**United States Environmental Protection Agency
EPA New England
One Congress Street, Suite 1100
Boston, MA 02114-2023**

January 21, 2003

**RE: Comments on GE's 2002 Annual Monitoring Report
Upper ½-Mile Reach Removal Action
General Electric-Pittsfield/Housatonic River Site**

Exhibit A - Upper 1/2 Mile Reach Removal Action

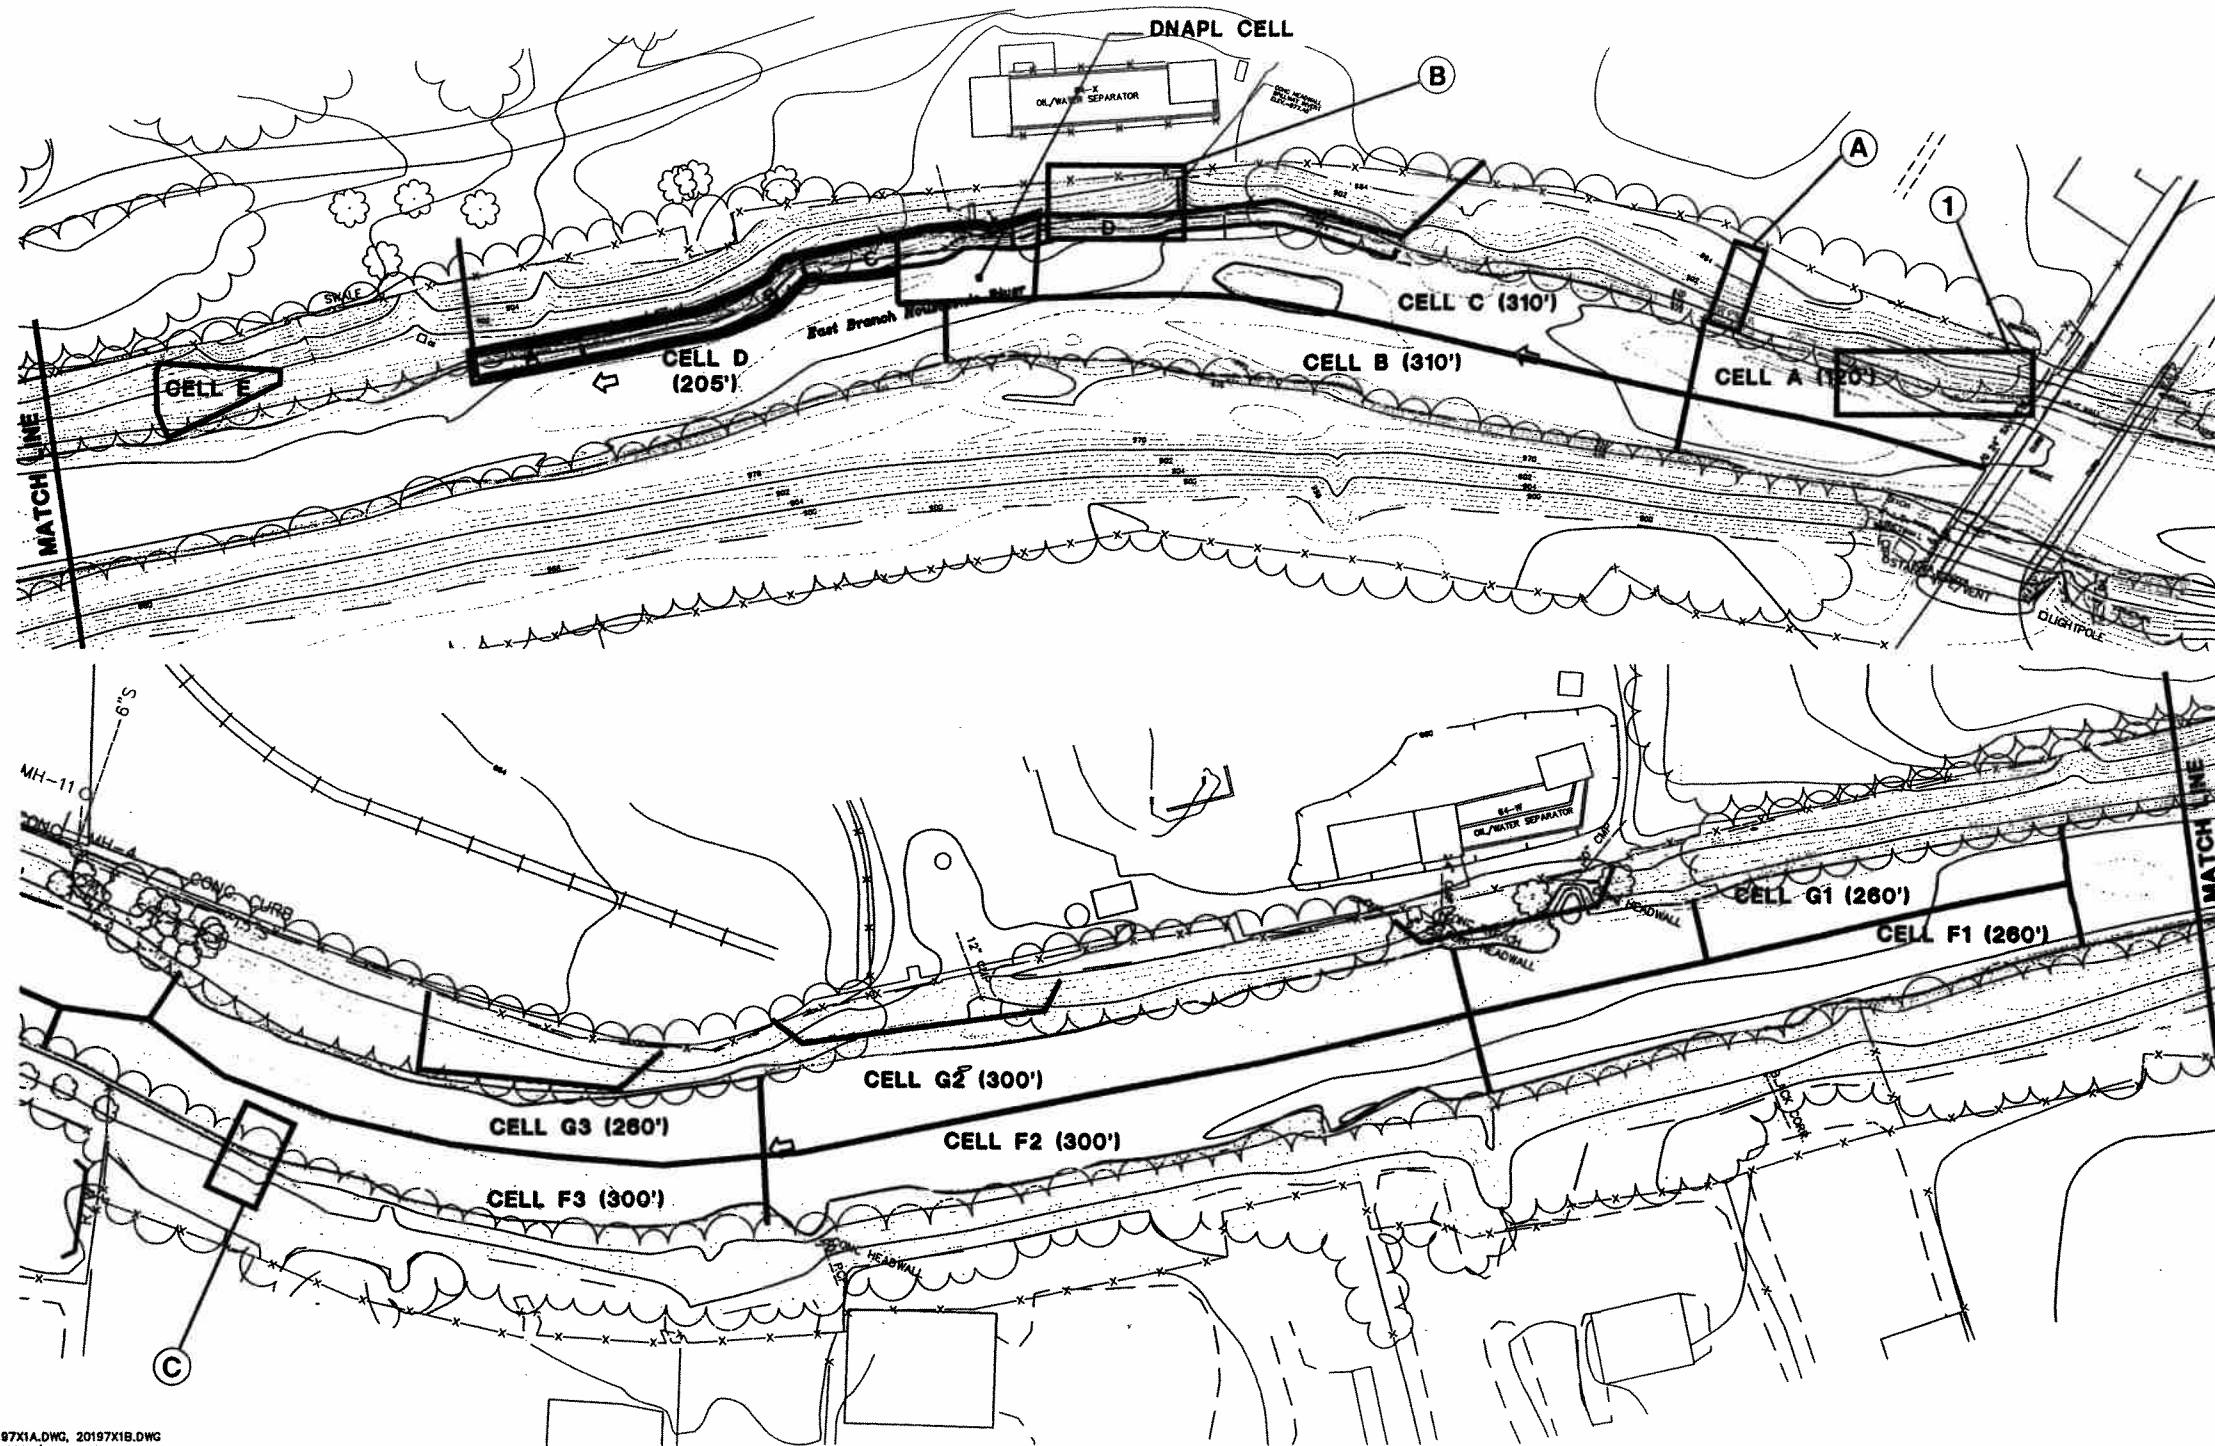
Area 1 - Approximately 2.0 cubic yards (cy) of soil appears to have eroded into the River from the northern bank area downstream of the Newell Street Bridge and upstream of Cell A (see Exhibit A). The source of eroded material was from the non-removal bank area near the edge of the river. The cause of erosion appears to be the combination of a high flow event (providing scouring action) flowing over the unprotected toe of bank. No evidence of eroded soil was observed in the adjacent River and, therefore, no removal activities are planned at this location. To reduce potential for future erosion in this area, the toe of the bank will be restored by placing and consolidating 9 to 12-inch diameter rocks (rip-rap) and blending into the existing adjacent bank areas (upstream and downstream) for a length of approximately 90 feet.

Exhibit B - Upper 1/2 Mile Reach Removal Action

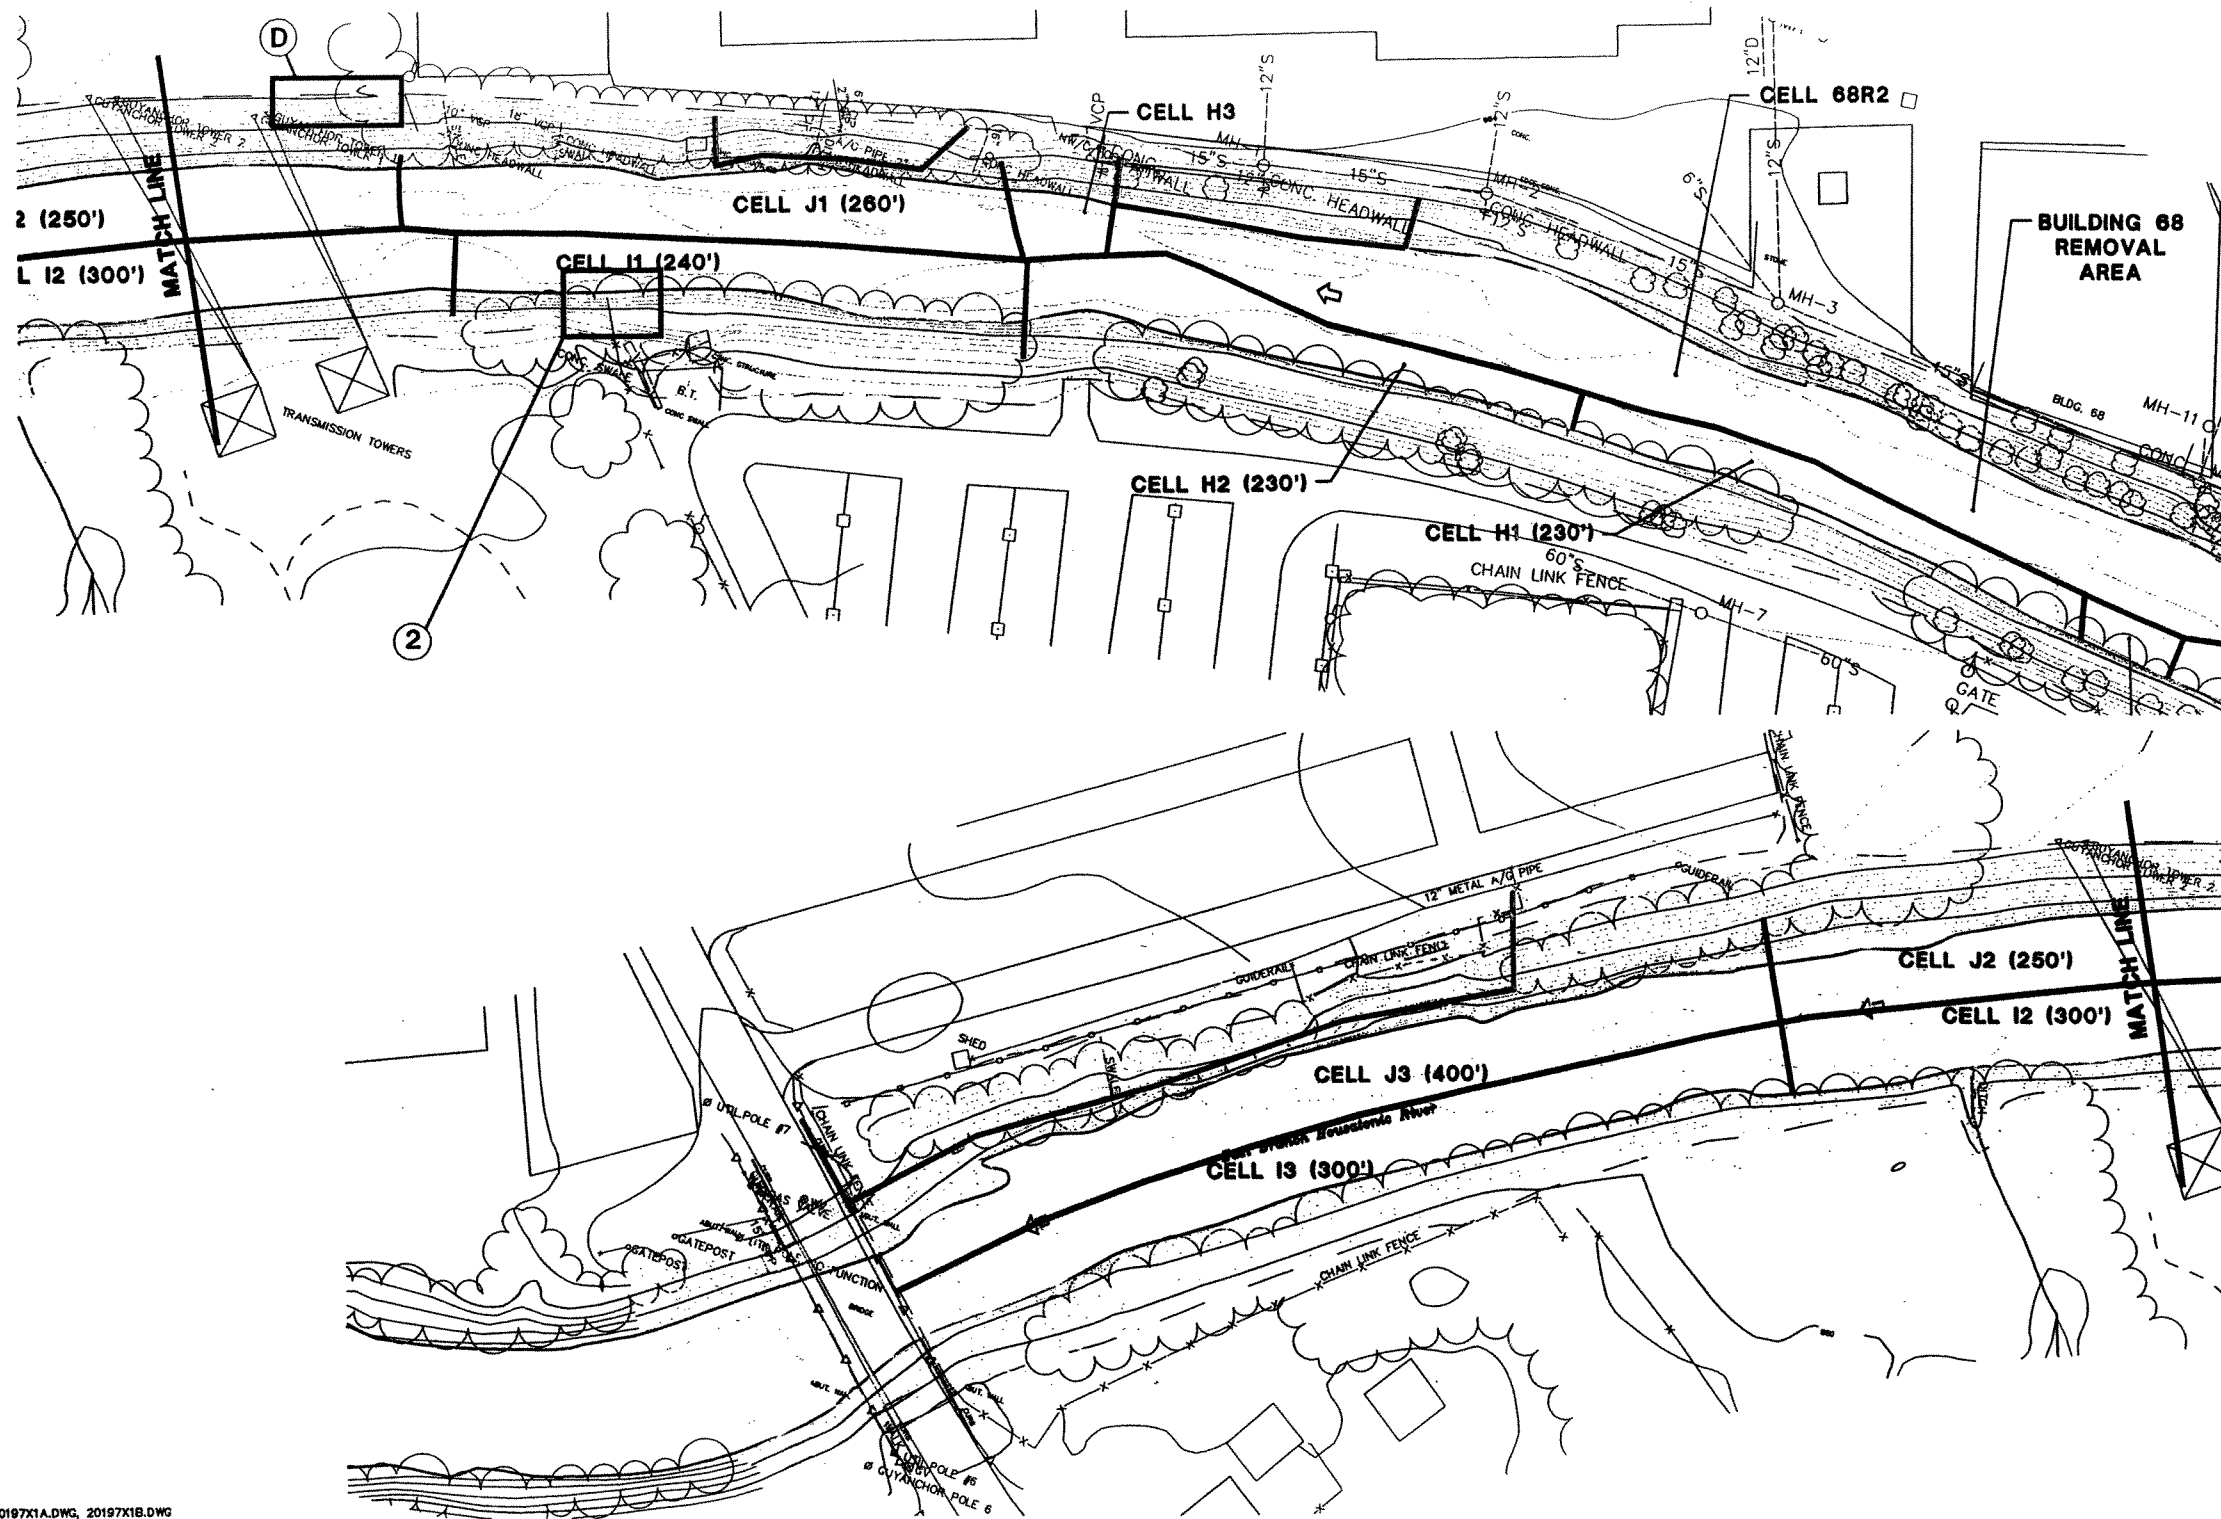
Area 2 – Approximately 1 to 5 cy of soil backfill eroded into the River near swale No. 11 (Cell I-1) on the south side of the River (see Exhibit B). The source of eroded soil appears to be from the sand layer that was installed as the bottom layer (below geotextile fabric) of restored swale No. 11. The erosion appears to have been caused by stormwater runoff flow below the geotextile fabric washing the underlying sand into the River at the base of the swale. To address the eroded material in the River, GE removed the sand from the River and placed the material in a stockpile at the top of the bank. This material will be disposed off-site with the additional bank soil to be removed from the top of the bank in the same area (associated with polygon for sample point RB-7). Analytical results from in-situ samples of the eroded material are presented in Table 2. To reduce possible future erosion in this area, stone dust was placed over the swale to fill the voids between the rip-rap to reduce the flow of water within the voids and below the geotextile.
